ORDER UNDER SECTION 96 (2) OF ACT, III OF 1901.

With reference to ^{his}_{their} application, dated — 192 .Mr. Whoreum ho olchans is informed
Messrs. arethat the plan submitted by ^{him}_{them} for building —— on plot No. 92 Survey Sheet O.T. 3situate in — Street, Old Town
Road

With reference to ^{his}~~this~~ application dated.....31.1.1928.....with aplan for the proposed ^{Building}~~additions~~ on plot No....92....Survey Sheet No....0.T.3

PLAN OF PROPOSED BUILDING ON
PLOT N° 92 SHEET OT-3 OLD TOW QUARTER
Scale 8" = 1"

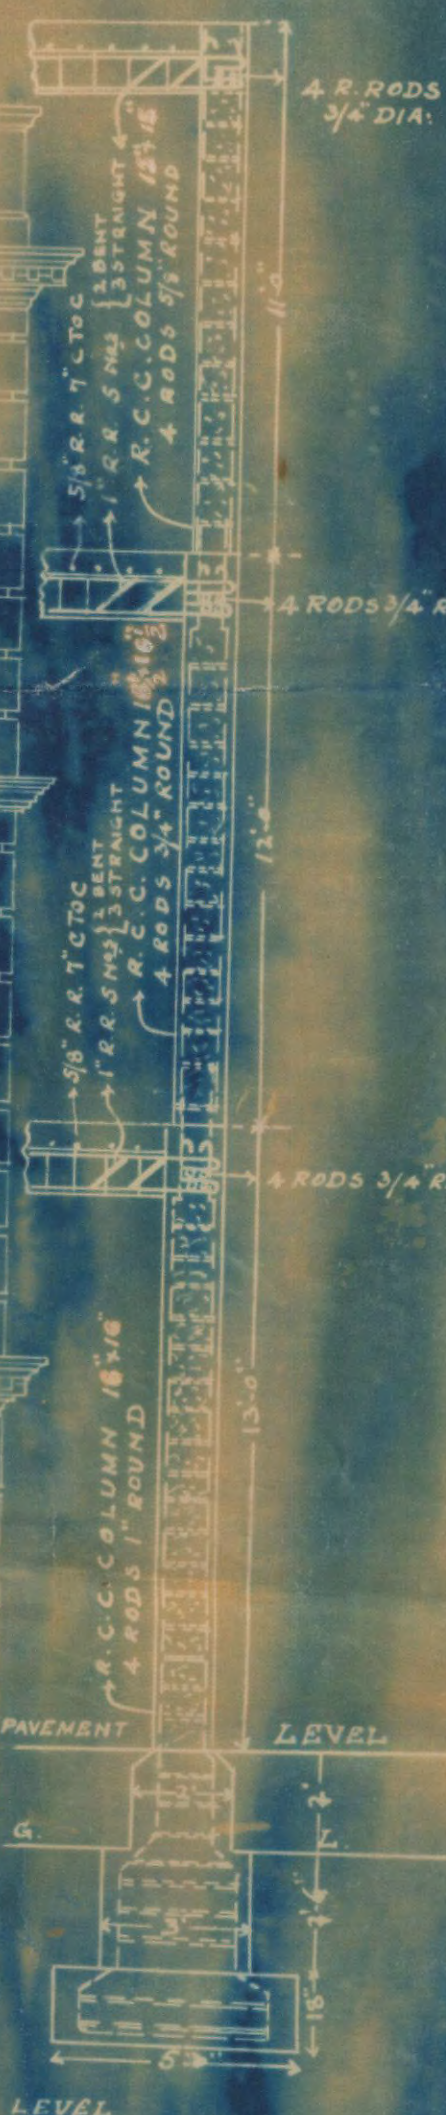
- (1) Section of the Sanitary block must be given.
- (2) Calculations req. A.C.C. beams, columns and floors must be given.
- (3) Open space in front of the rear rooms must be left 13'
- (4) External walls should be placed for such a big plot
- (5)
- (6) There is some land to be granted and some acquired and therefore the exchange will
- (7) have to be sanctioned by the Managing Committee and Commissioner - in final and
- (8) the plans will require to be corrected
- (9) accordingly ~~thereafter~~

- (1) Section of the sanitary block must be fixed
- (2) Calculations re R.C.C. beams, columns and floors must be given.
- (3) Open to sky space must be fully dimensioned.
- (4) Kitchen must be grated over the door.
- (5) Clear headway not less than 6 ft must be provided for the stairs
- (6) C.B. Partition wall along the side of stairs must be at least 6" thick.

Remarks Plan must be corrected as per alignment set back.

There is some land to be granted and some acquired and therefore the exchange must be sanctioned by the managing Committee & Commissioners in S.D.

Why? Name of the road mentioned as Cloth market Road must be changed into "National Lane"

1. Section of sanitary block is similar to the Main Building and you did not insist upon it after I explained to you.
2. Details of R.C.C. work are shown on the plan.
3. As personally explained I have shown on the Block Plan the land that will be available from Plot No:90. My client will have no objection to get this from the Municipality & thus his building will abut on the Atmaram Lane.

As personally explained I shall in the mean time delete the second floor and build it after the adjoining plot is actually acquired.

4. You had personally no objection to allow the external wall as proposed by me provided the Executive Engineer approved of the arrangements. I saw Mr: Sethna in this connection & he has no objection to the proposed outer walls being 6" thick of cement blocks.

5. I find at site that there is no land available on the south side which could be granted to my client. But if there was any such land available it would not be worth while to wait till that land is sanctioned & my client is not prepared to go in for it *if the plans are delayed on that-account.*
